General Service Bulletin

HCOM-SB-70A

Added oil line modification for 8 cylinder Model "E" hermetic compressors.

SUBJECT: MODEL "E" COMPRESSOR PARTS INTERCHANGEABILITY

Figure 1
Replacement Piston
Ring Set (RNG-77)
for 2-Ring Pistons

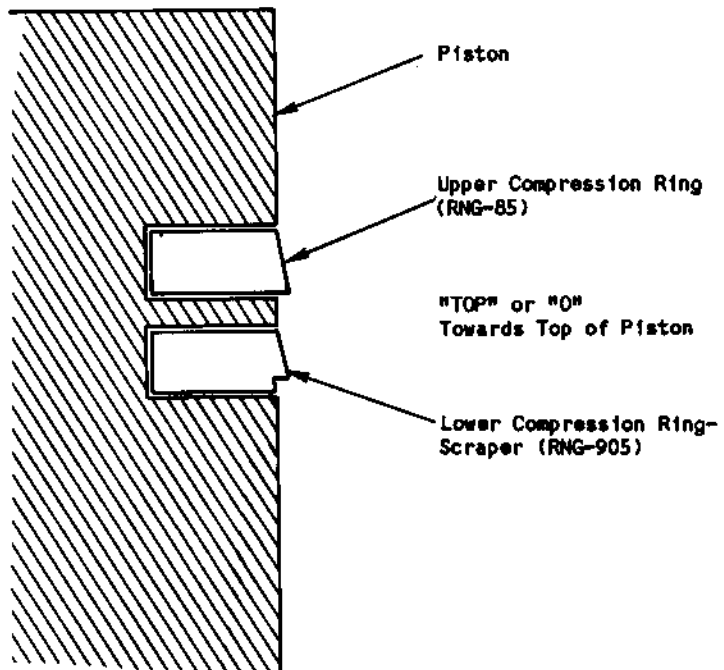
The Model "E" compression rings have been changed to a design with a tapered face, which allows them to seat faster. The tapered face piston rings are completely interchangeable with flat face rings. The tapered rings must be installed properly. Refer to Figures 1 and 2 for proper installation.

The piston itself has also been changed from an elliptical shape to a round shape, and the oil ring has been removed. The elliptical and round pistons are completely interchangeable. The tapered piston rings must be used with the round, two ring pistons. Piston ring set RNG-77 has been changed to include one tapered compression ring, one scraper compression ring and one oil ring, so that the set can be used for three ring or two ring pistons.

1. Piston rings must be installed with the "TOP" or "O" up. Instructions ship with the piston rings.
2. The 2-ring pistons must use one each of the tapered upper and lower (scraper) compression rings only.
3. The oil strainer hold down retaining spring (SPG-30) is no longer required with the round strainer, but will be available for earlier style strainers, if required.
4. Magnets are a recommended addition when the compressor is rebuilt.
5. The redesigned compressor housing (larger standpipe and improved venting) does not affect the bearing head assembly.

Figure 3
Redesigned Crankshaft for Model "E"
Open and Hermetic Compressors
(4 - 8 Cylinder)

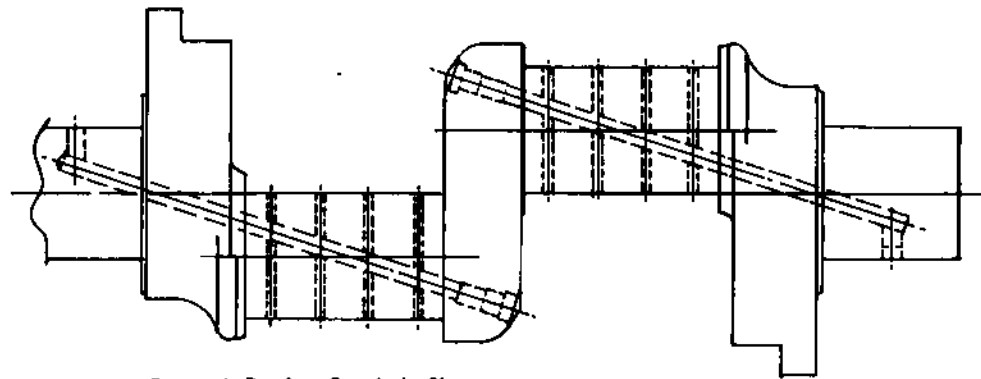
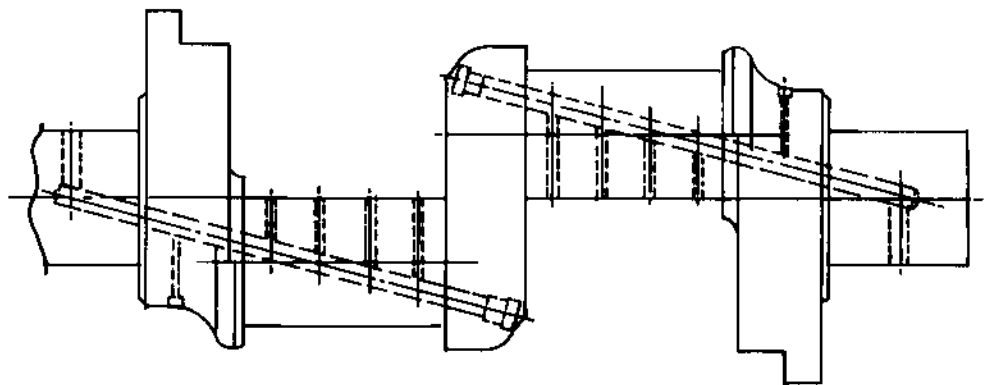
The compressor crankshaft has been redesigned to eliminate oil passages that go all the way through the connecting rod journals. Additional crankshaft venting has also been added. See Figure 3. The crankshafts are completely interchangeable.

Figure 4
Standpipe and
Oil Strainer
Locations

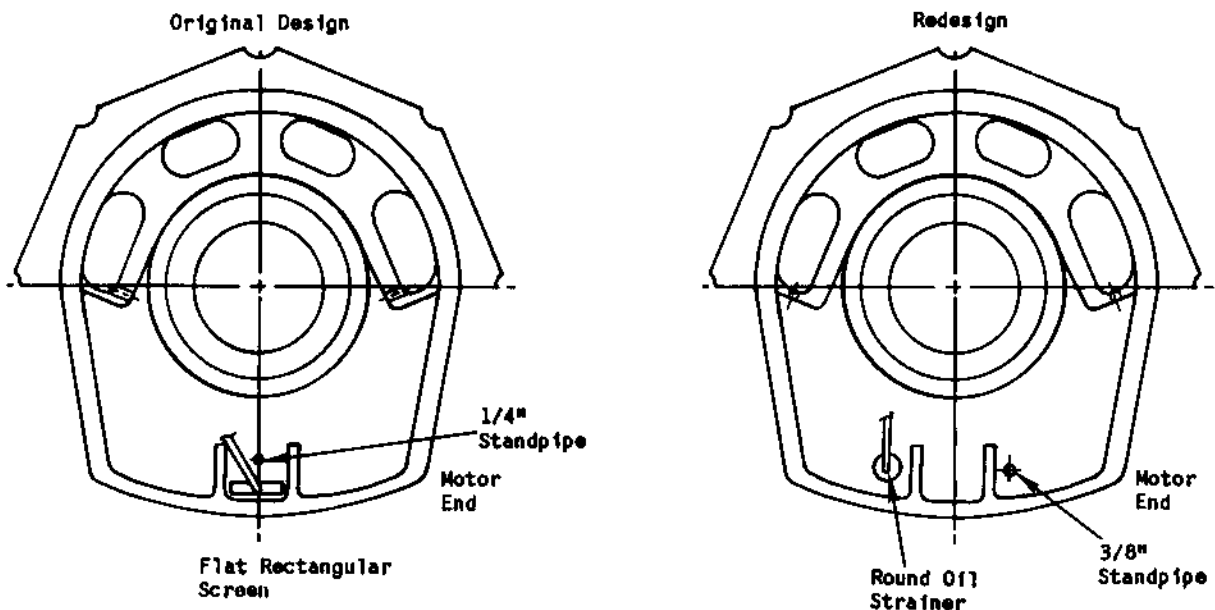
The oil strainer has been changed from a flat rectangular design to a round design. The round oil strainer is a direct replacement for the flat rectangular oil strainer. The round strainer will be located to the side of the compressor crankcase and connects to the existing compression fitting in the compressor housing. The oil strainer spring is not required for the round strainer, but will be available for earlier style strainers, if required.

Due to crankcase modifications, venting system changes have been made to the oil return standpipe and the motor end bearing head. The standpipe has been relocated, and the size of the opening has been increased from 1/4 inch to 3/8 inch diameter. See Figure 4.

Figure 5
Magnet Mounting
Locations

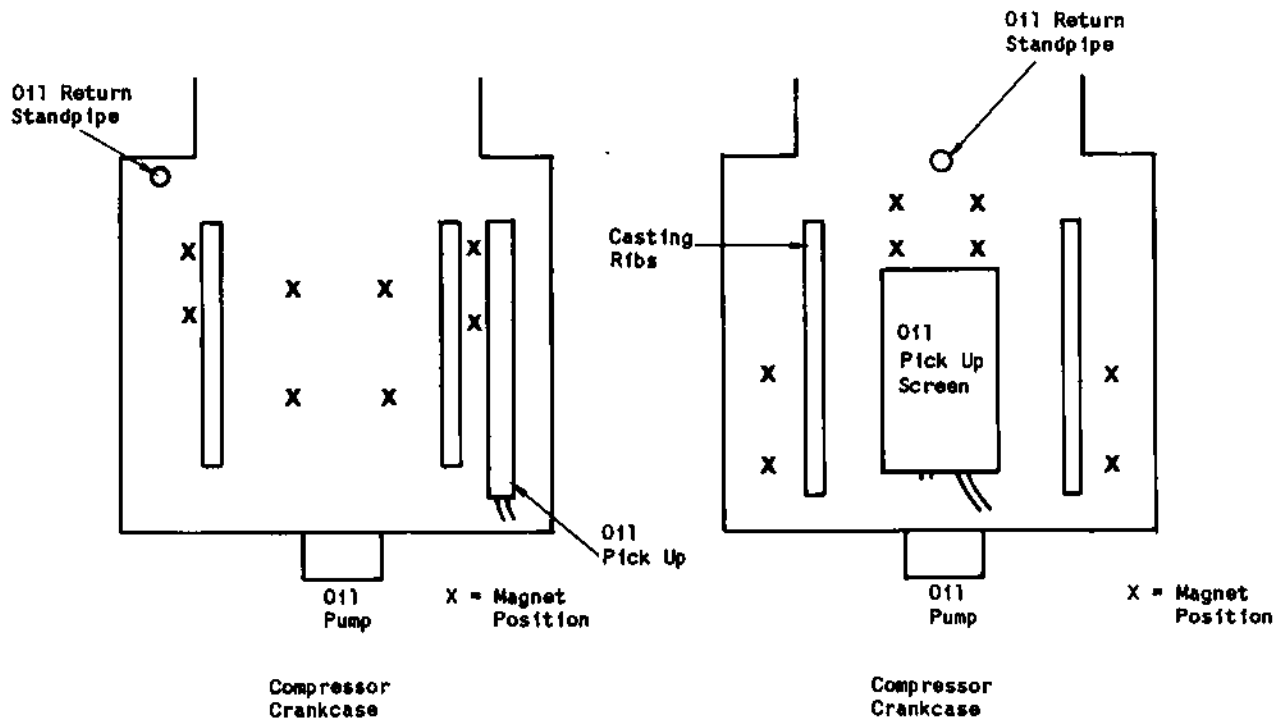
Eight magnets have been added to the compressor crankcase to catch loose iron particles. These magnets should be added during a compressor rebuild. Refer to Figure 5 for the magnet mounting locations.

Figure 6
Model "E" 8 Cylinder Hermetic Compressor -
Original Location of Oil Line Number 7

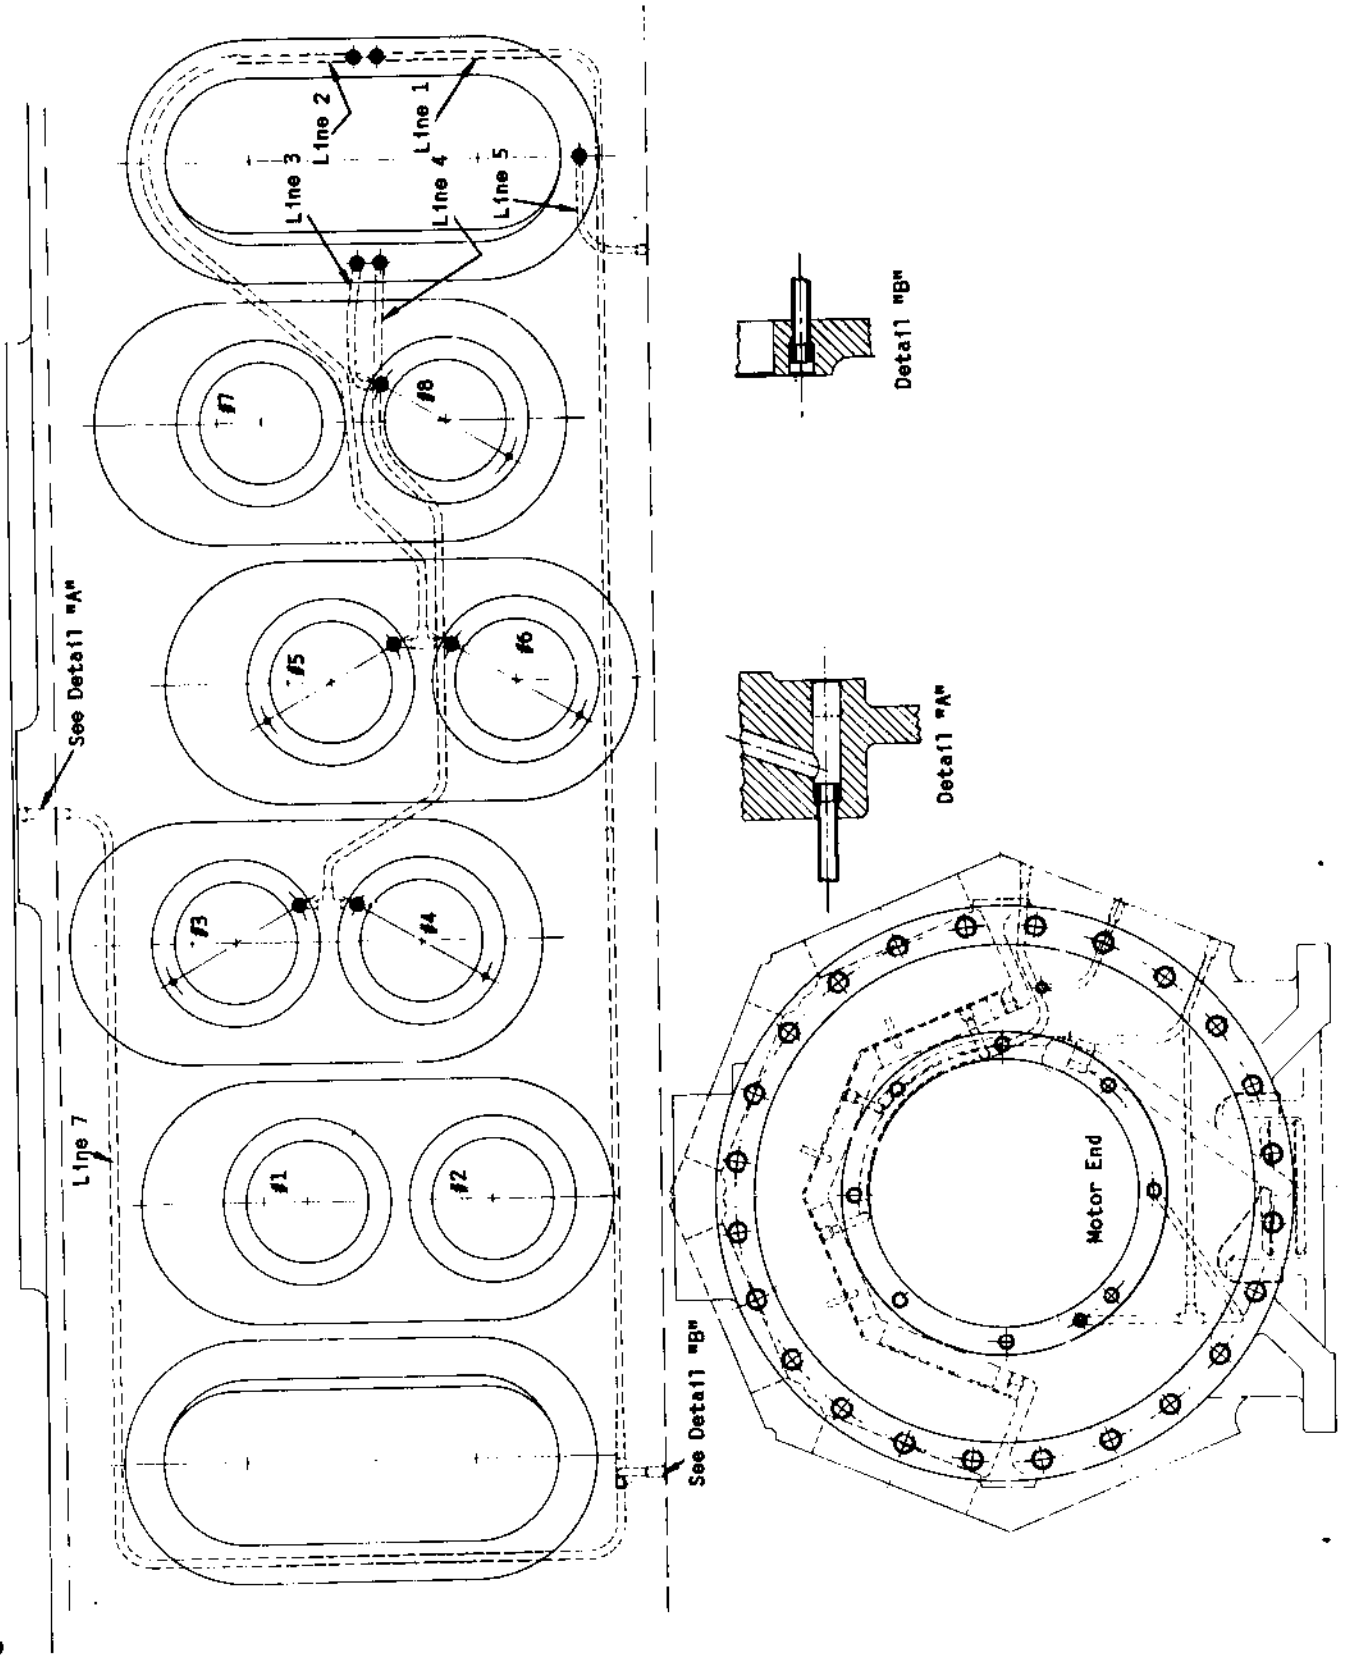
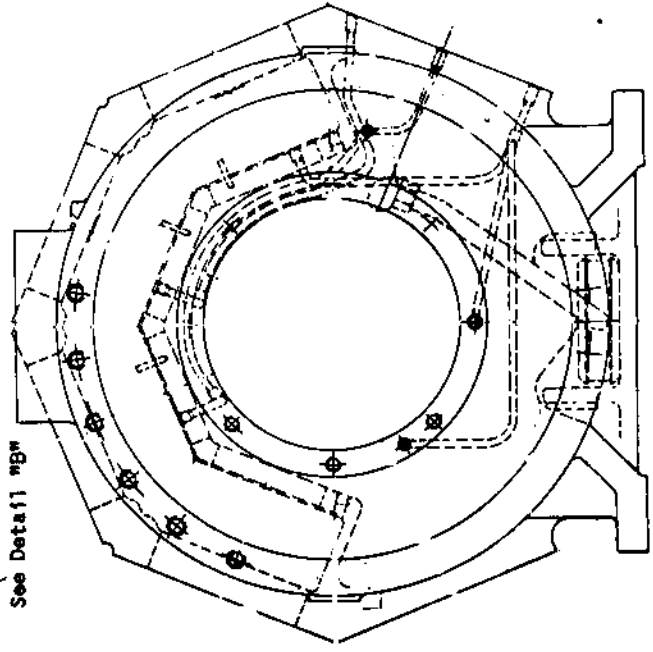
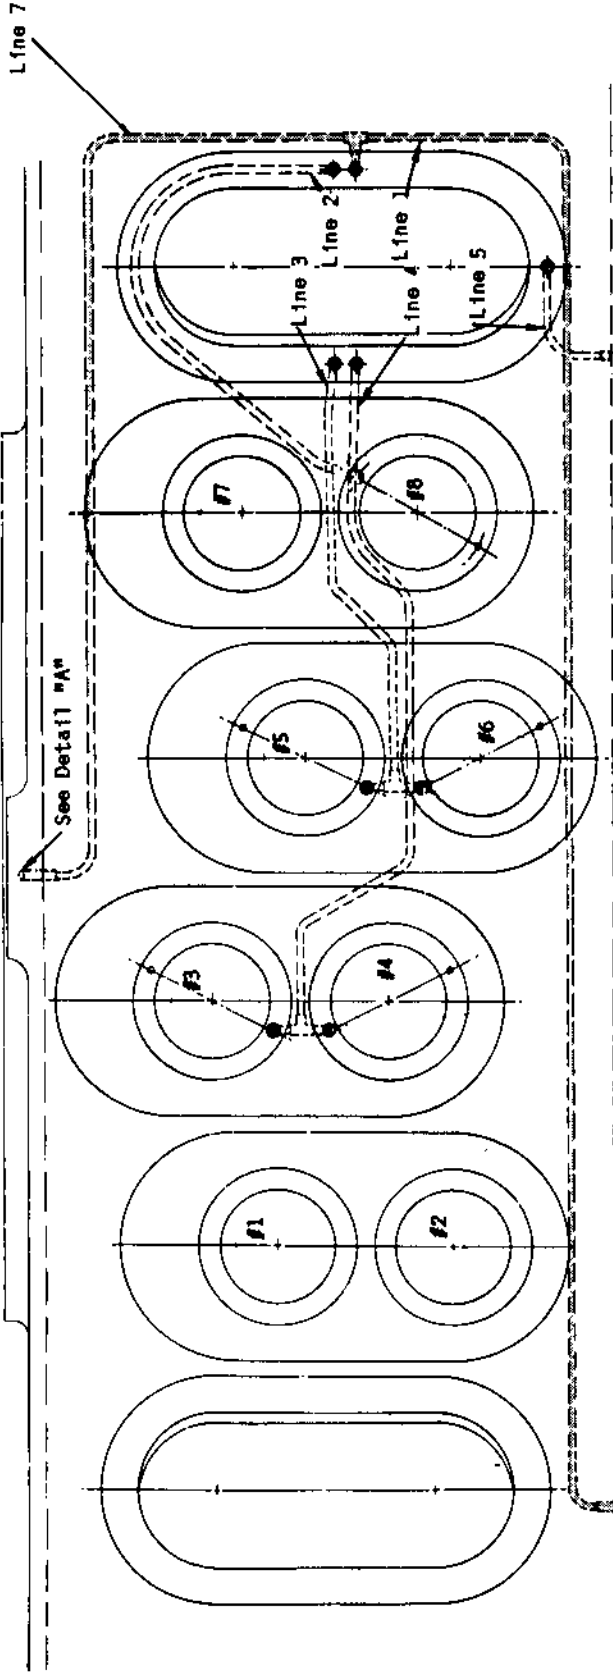
On 8 cylinder Model "E" hermetic compressors with oil lines as shown in Figure 6, it is recommended that oil line number 7 be modified to obtain proper oil pressure at the handhole cover. This oil line can be removed and updated to the current oil line as shown in Figure 7. Oil line kit number KIT-142 is required.

1. All tubing must be cut with a saw only, to avoid work hardening.
2. All tube lines must clear handhole opening area.

Figure 8
Alternative Oil Line Modification

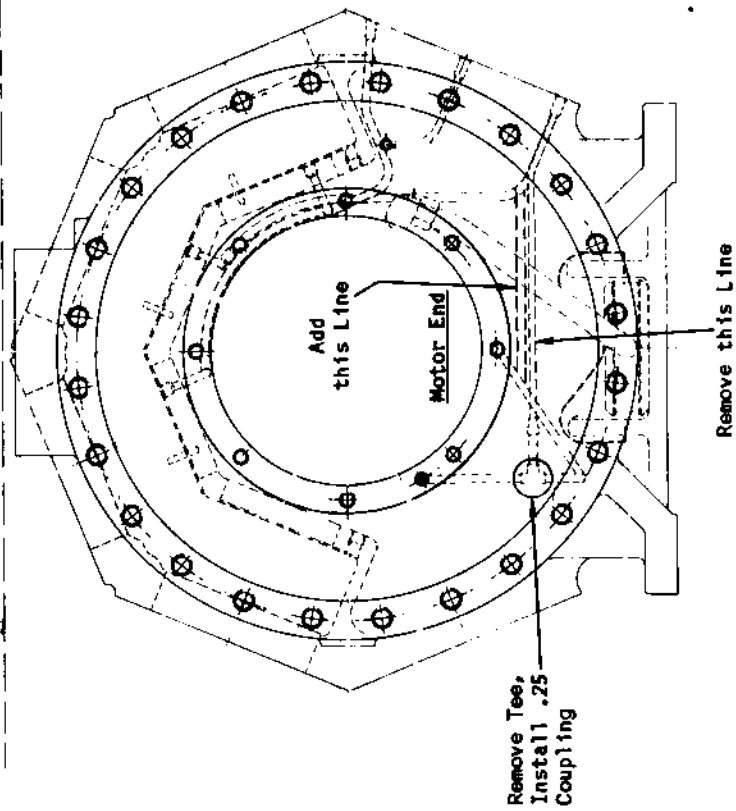
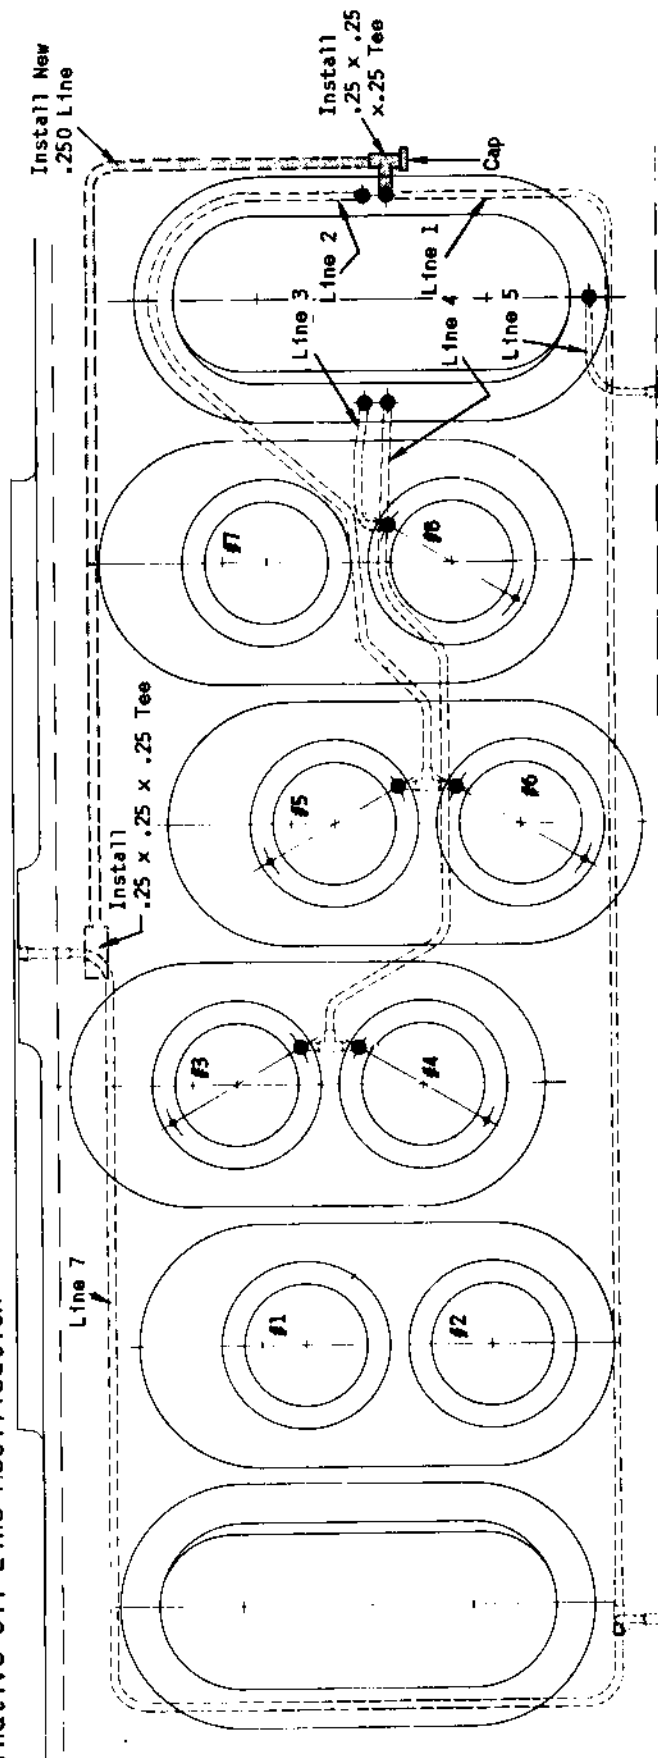
An alternative modification is shown in Figure 8. This modification changes the oil supply to the handhole cover from the motor end main bearing to the pump end main bearing.

1. All tubing must be cut with a saw only, to avoid work hardening.
2. All tube lines must clear handhole opening area.
